**TRANSMISSION 722.700 ## as of 0129631 as of 24.1.01,
722.701 ## as of 0132072 as of 8.2.01**

P27.60-0421-01

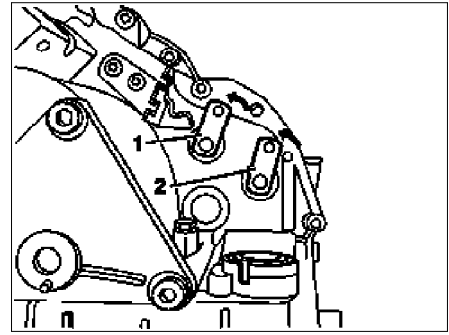
Because of the deletion of the shift lock cable ignition lock the lever for the shift lock cable ignition lock (1) at the transmission is likewise deleted.
